Access Compliance Report

| Intersection ID: 50446 | Main Street: ALICE_MCGINN_DR | Cross Street: HAWFIELD_WOODS_LN | Location: SE |
| ADA ID: E24451FDDF72 | Ramp Type: Perp | Initial Pass/Fail: Fail | Overall Compliance: No |

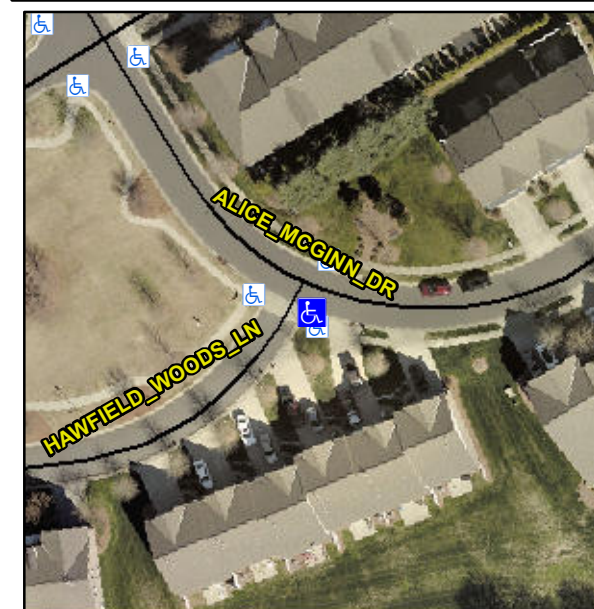
Not Found, R304.5.3

| Compliance | Description | Data | Compliance | Description | Data |
|------------|-----------------------|-------|------------|-----------------------------|------|
| Yes | Ramp Width (in) | 48.0 | No | Ramp XSlope (%) | 5.4 |

Remove & Replace Entire Ramp.
